NUREG-1437, Supplement 38,
Vol. 3

Generic Environmental Impact Statement for License Renewal of Nuclear Plants

Regarding Indian Point Nuclear Generating Unit Nos. 2 and 3

Final Report Public Comments Continued, Appendices

Figure 2: The standardised juvenile index for white catfish in the Hudson, showing a decreasing trend though time. The trend is significant ($a = -0.0136$, $b = 27.216$, $F = 14.0414$, $p = 0.0008$) (Seaby and Henderson, 2007)

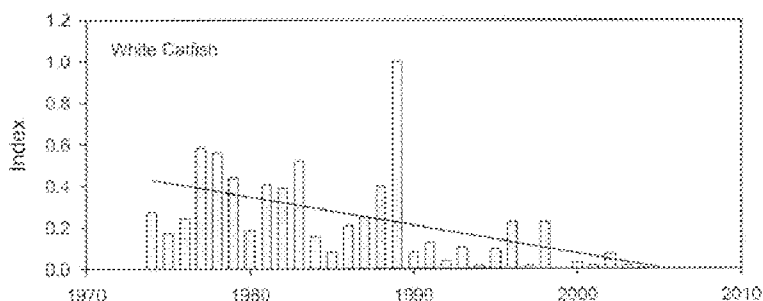
The Year Class Reports for the Hudson River Estuary Monitoring Program shows that, river-wide, juvenile white catfish have been in a steep decline in abundance since 1990 (Figure 2).

It is therefore unsurprising that in Table 4-4 (see Figure 1) the population line of evidence is for a 'Large' potential adverse impact. The trend shown in Figure 2, which is statistically significant, certainly seems to correspond with the definition of Large given on page H-33, NUREG-1437, Vol 2:

Figure 3: The standardized juvenile index for weakfish in the Hudson showing a decreasing trend though time. The trend is significant ($a = -0.0155$, $b = 31.0218$, $r^2 = 0.0134$) (Seaby and Henderson, 2007)

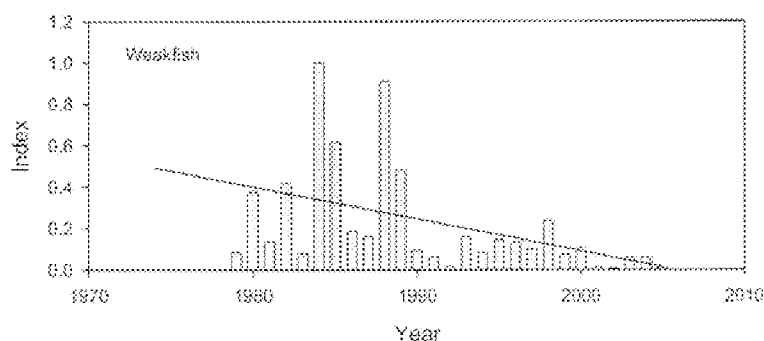
Like white catfish, weakfish have also shown river-wide a steep decline in abundance since 1980 (Figure 3). However, unlike white catfish, for this species Table 4-4 classifies the population line of evidence as 'Small'.

Figure 5: The standardised juvenile index for rainbow smelt in the Hudson.

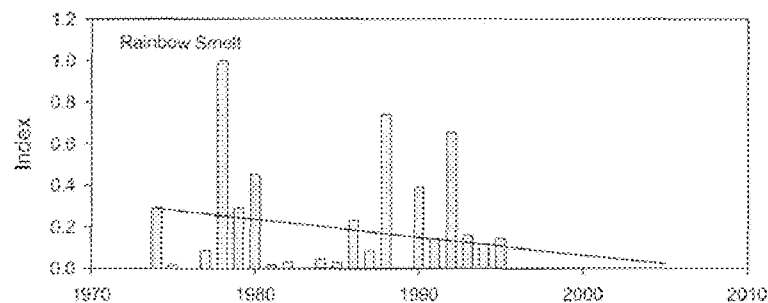
Juvenile rainbow smelt have disappeared from the survey since the mid 1990s (Figure 5), and it is therefore unsurprising that Table 4-4 assesses the population line of evidence as 'Large'. However, the impact of Indian Point 2 and 3 is assessed as moderate because the strength of connection is assessed as 'Medium'.

Examination of Table 1-32 (Figure 4) shows why the overall impact is only 'Moderate'. This table shows that both the impingement and entrainment of rainbow smelt has been appreciable, and entrainment has been given the highest score possible of 4. However, the strength of connection is only medium because both the impingement and entrainment prey scores are 1. The reason for this is stated in NUREG-1427, Vol. 2 page 1-41.

Figure 6: The standardised juvenile index for tomcod in the Hudson showing a decreasing trend through time. [Seaby and Henderson, 2007]

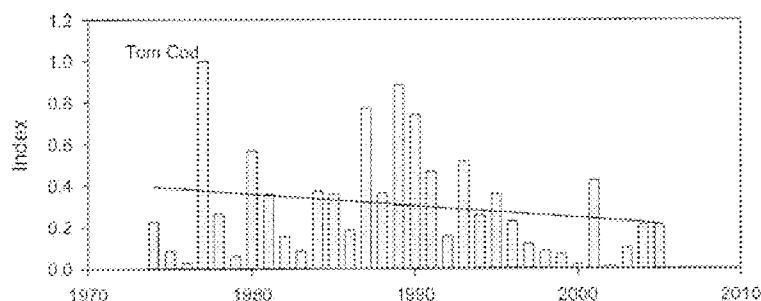
Examination of Table 1-32 (Figure 4) shows that a number of the RIS species have a prey score for impingement and entrainment of 1, and thus are unlikely to score highly for the strength of connection. This feature of the scoring protocol is thus central to the final outcome. The Atlantic tomcod makes a telling further example. The tomcod population shows considerable year-to-year variation, but appears to be in long-term decline (Figure 6). The average standardised index from 1975 until 1995 is 0.158; in comparison the index for the last ten years of sampling (1996-2005) is only 0.0617. In the last 10 years, only 2001 produced a good recruitment, although there are signs of a recent slight improvement in tomcod numbers.

While the population line of evidence for a decline is large, the invertebrate prey of this species is primarily responsible for the low-to medium strength of connection and the final conclusion that the impact is small to moderate.
